WHITNEY POINT RESERVOIR

DESIGN MEMORANDUM NO. I

MASTER PLAN

SUBJECT: Whitney Point Reservoir, New York, Design Memorandum No. 1,
Master Plan

WHITNEY POINT DAM AREA
SITE NO. 1

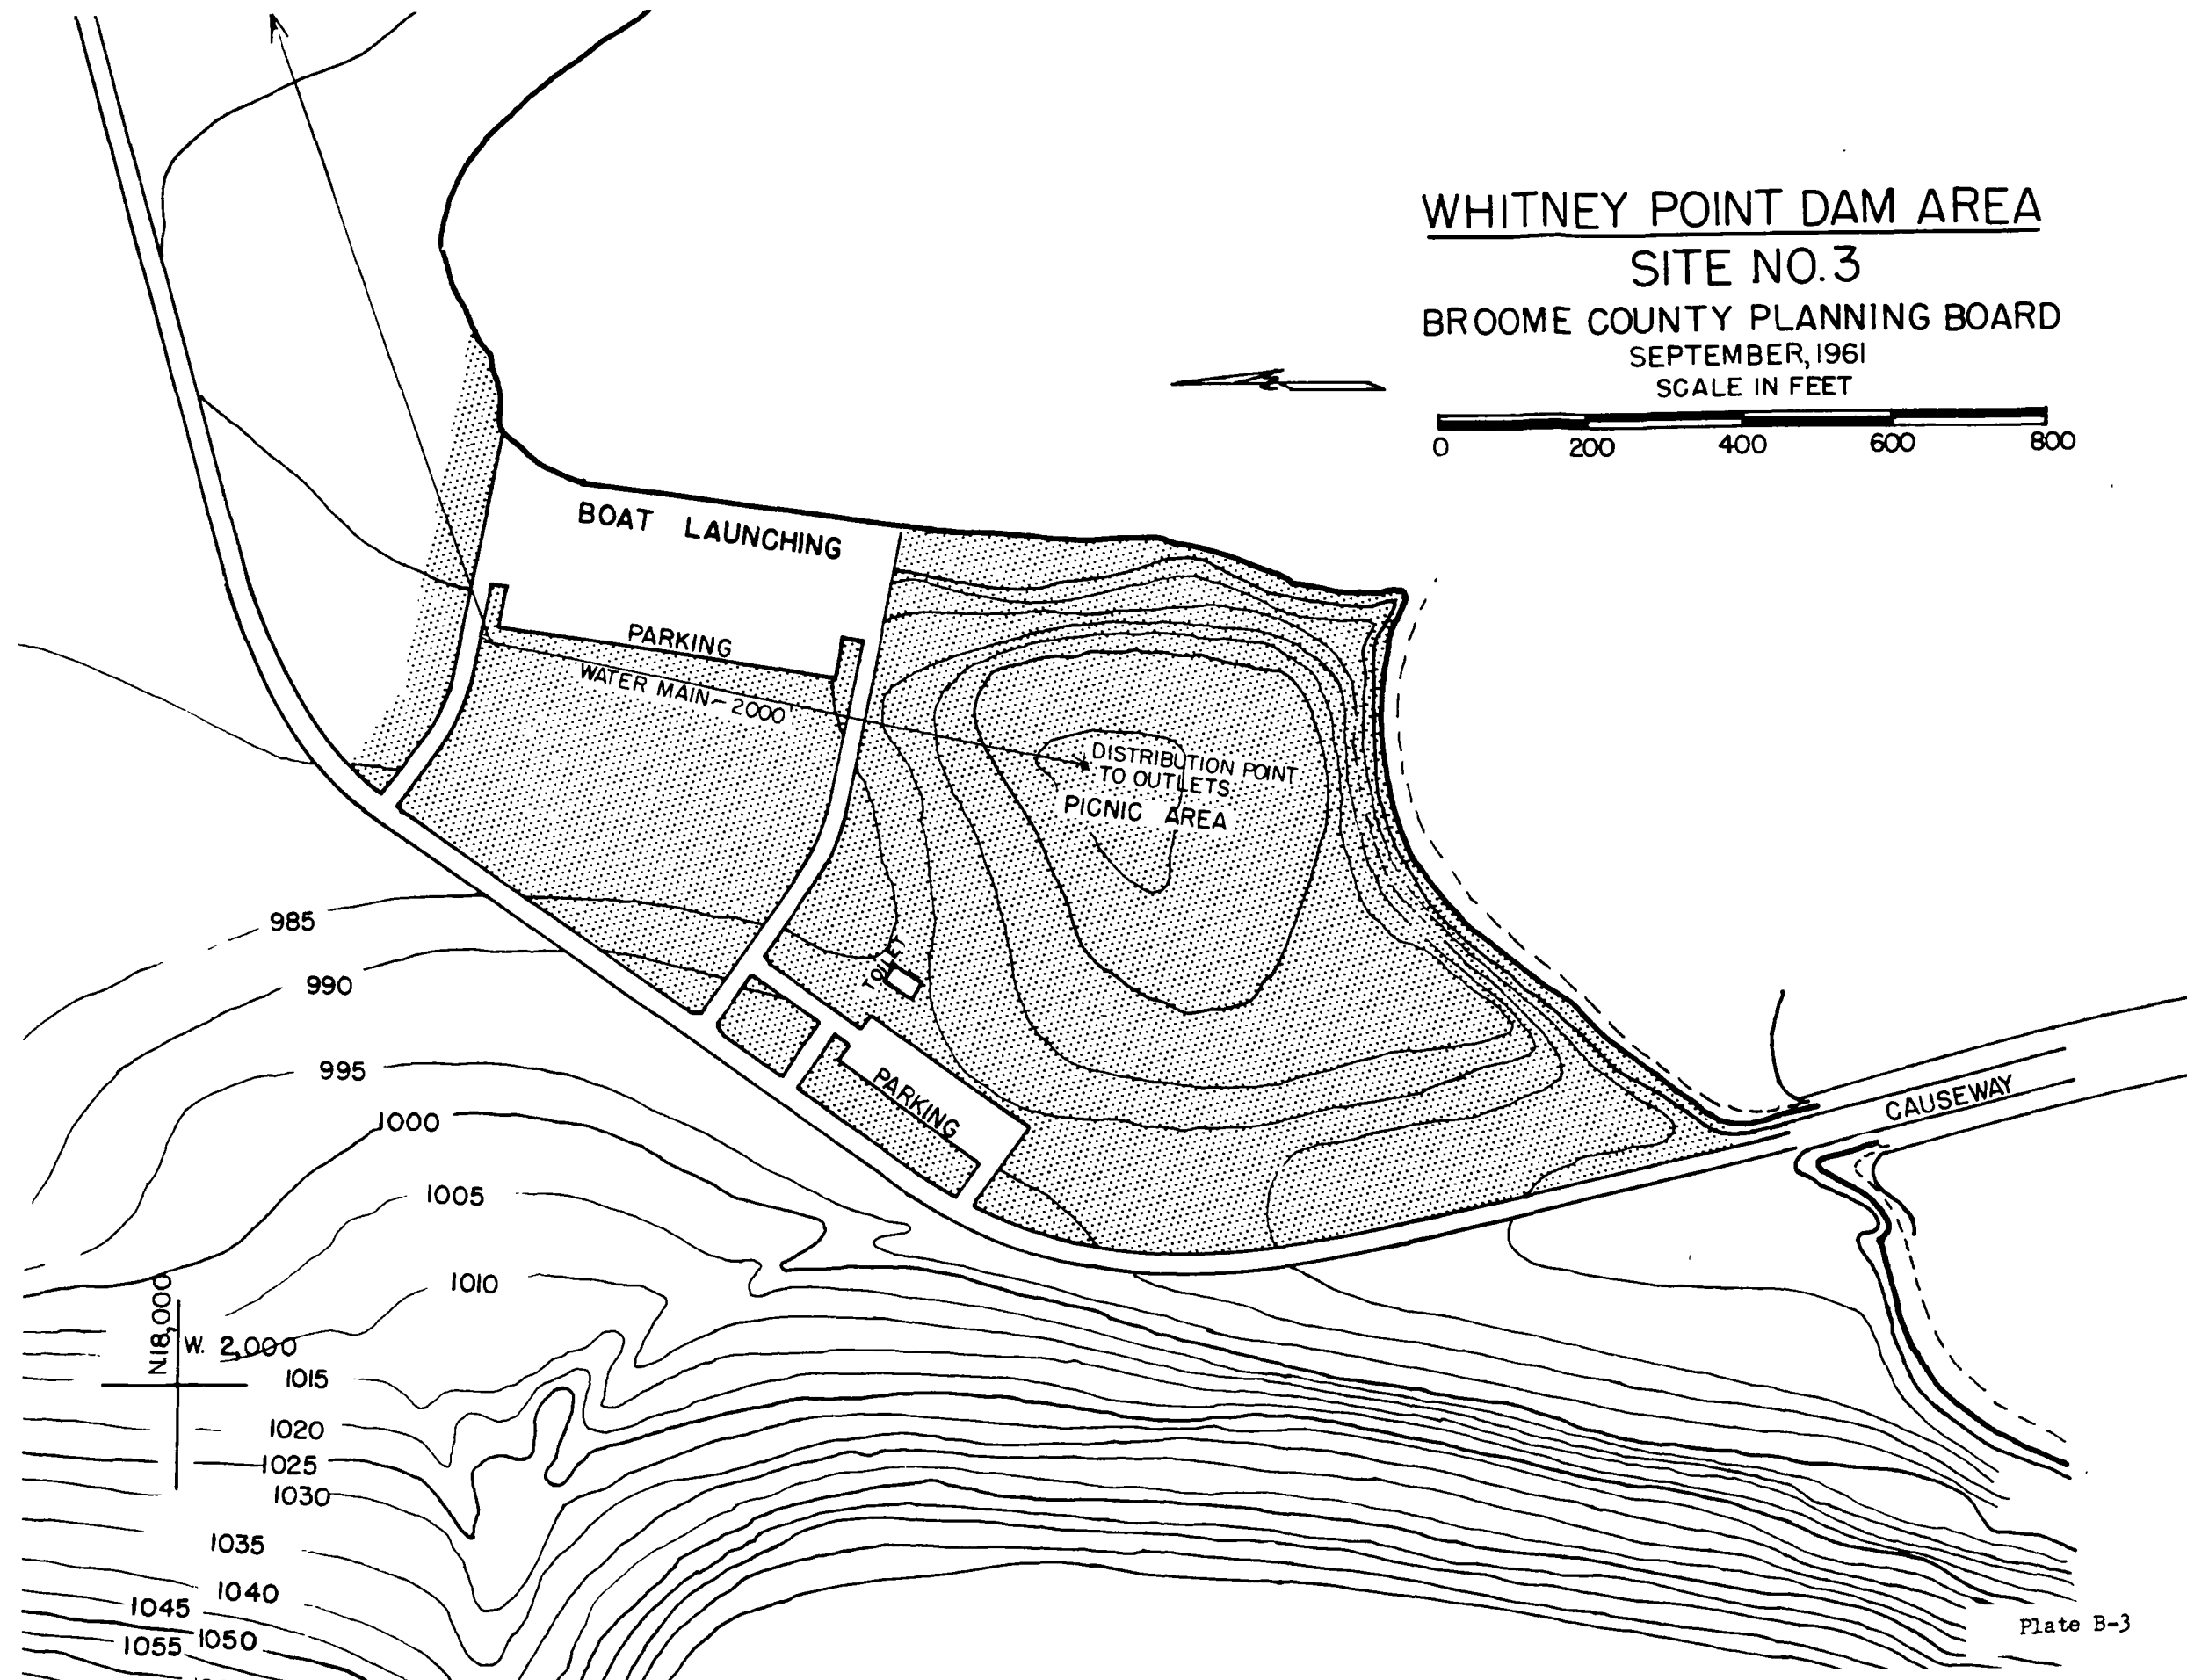
e. SITE PLANS AND COST ESTIMATES. Site Number 1.
Total cost appears to include road costs instead of the costs for
Picnic Area "A" alone.

Plate B-1

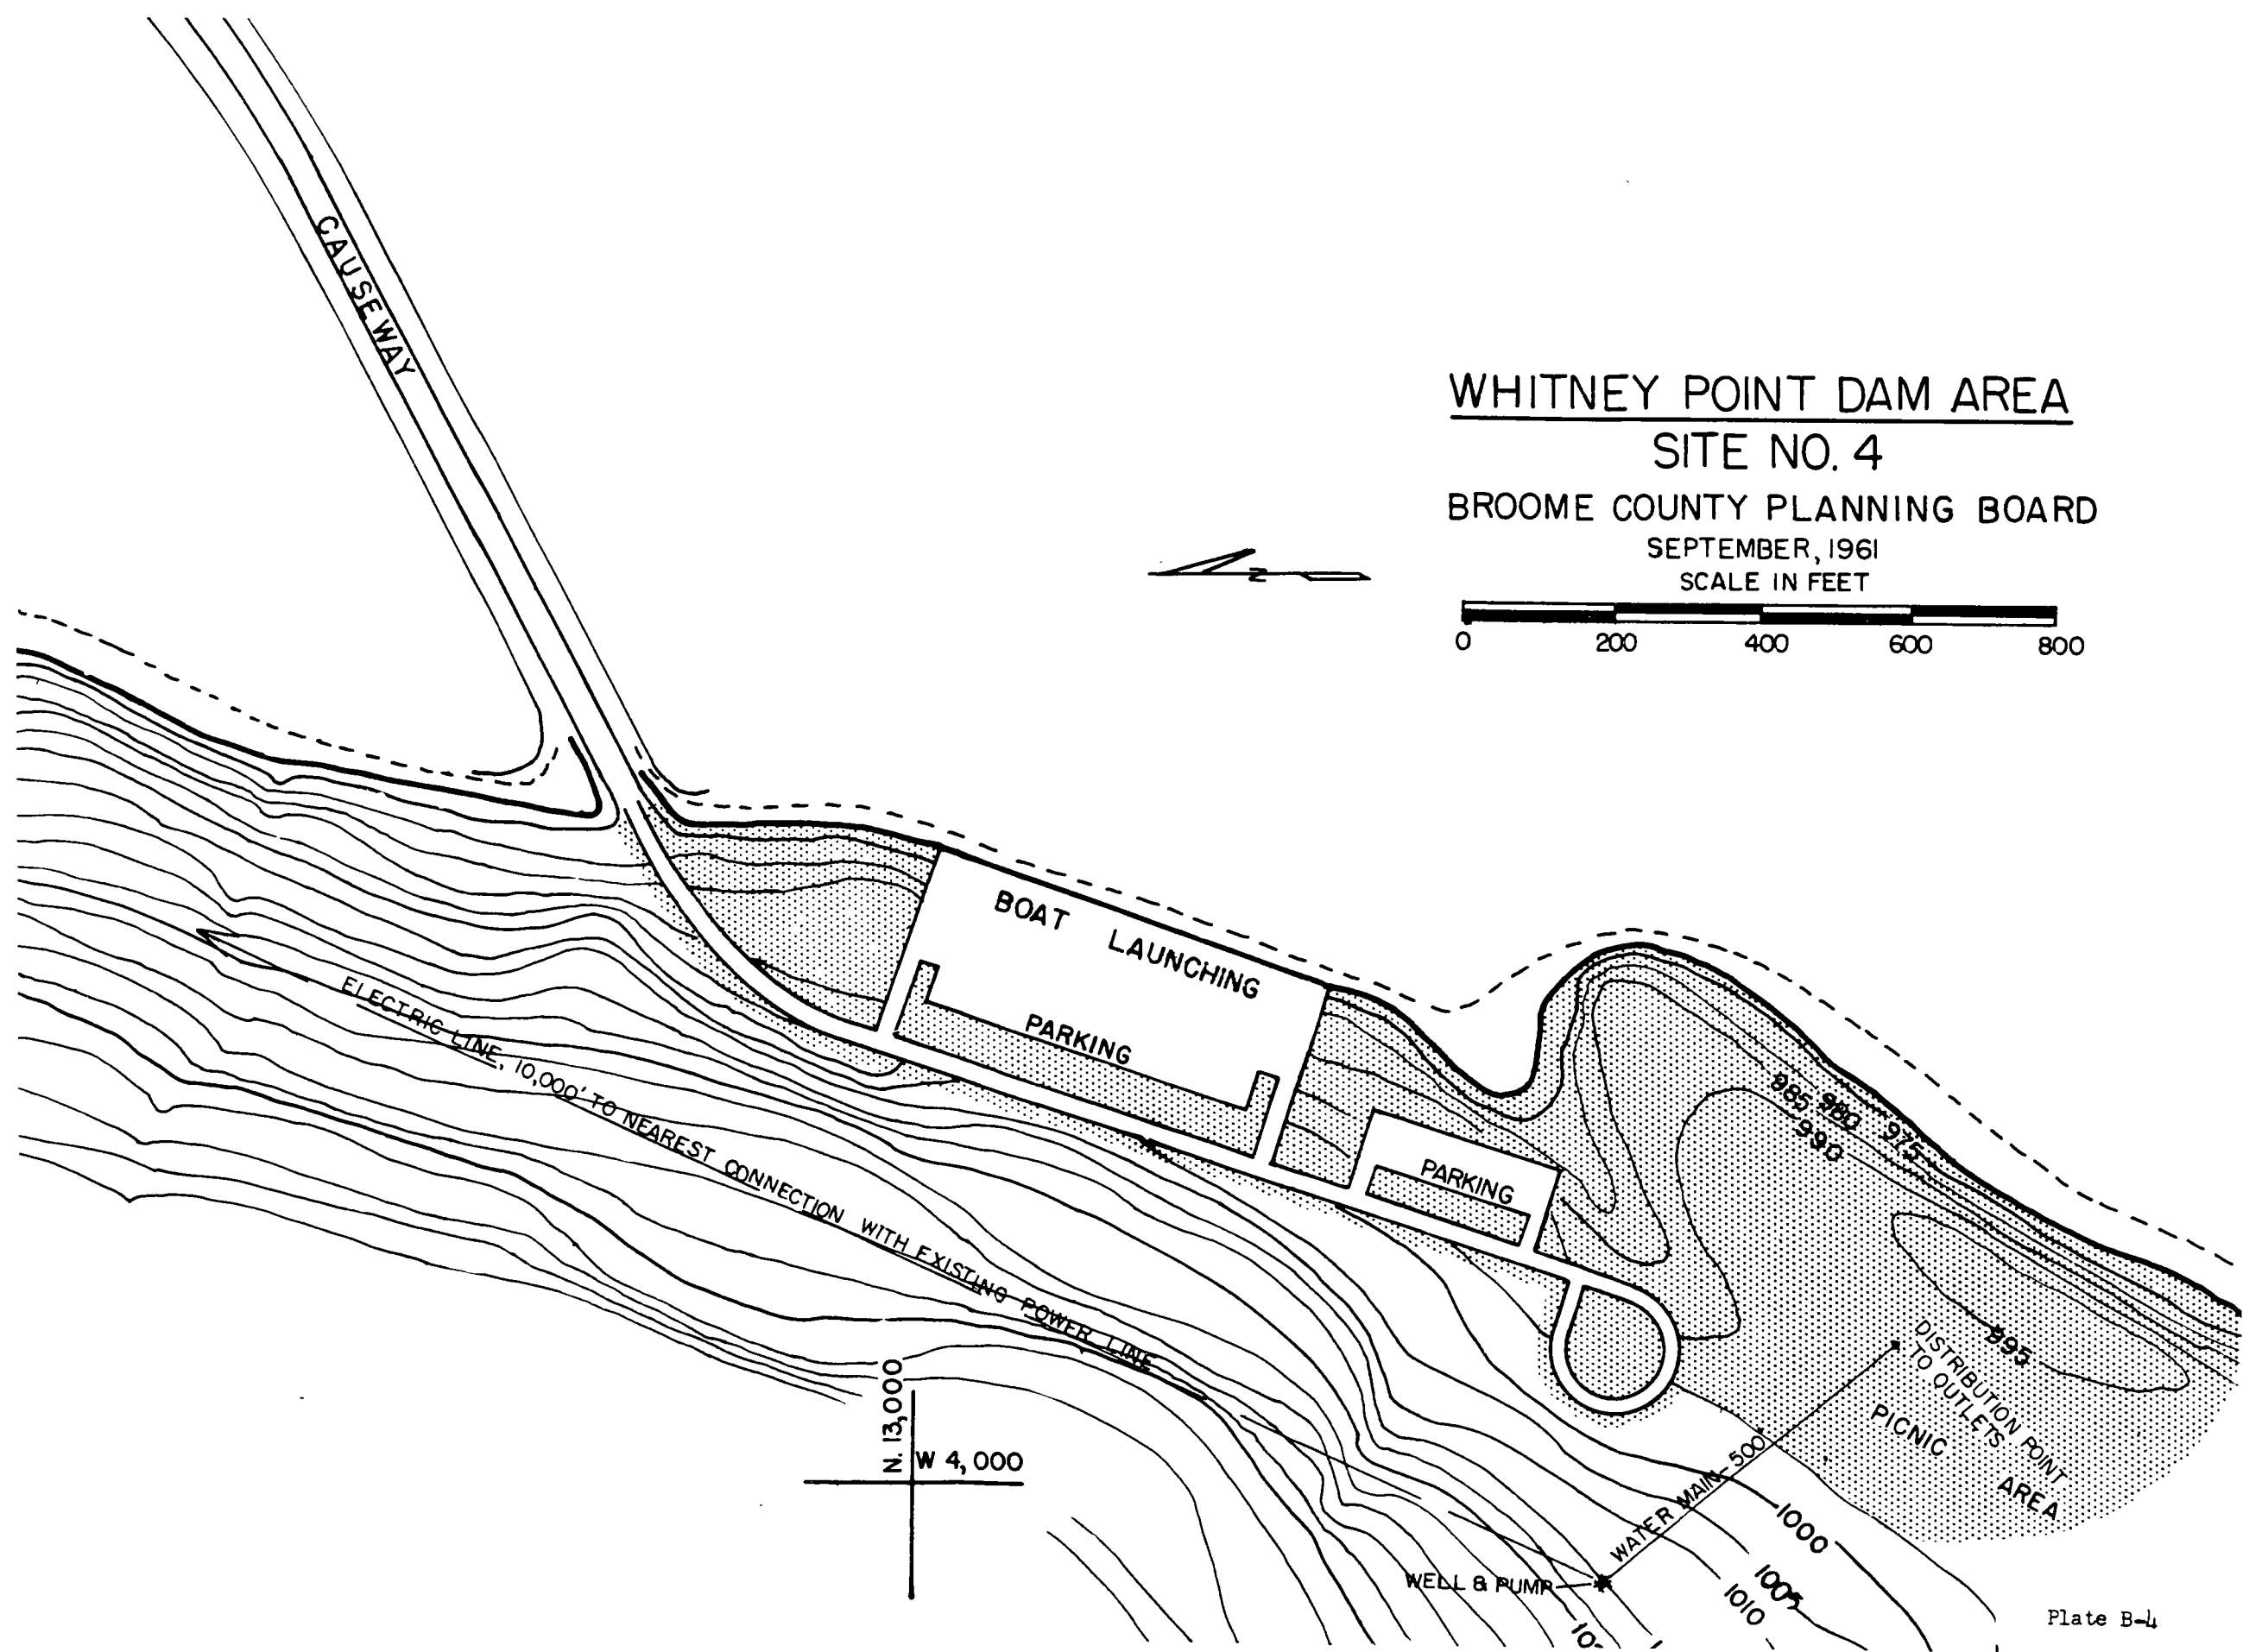
c. Plate 3 and Plate B-1 appear to be inconsistent with
respect to use of the intended recreation areas. Some explanation
seems necessary to account for the parking area between Picnic Area "A"
and the boat launching parking area.

1. As discussed with Mr. Hubbard of NAD during his recent visit to this office, appendix B is a plan prepared by Broome County; and, while it is realized that the plan could be improved in some areas, it presents, in general, the proposed plan of development by the county. This office did not feel justified in requesting the county to revise its plan.
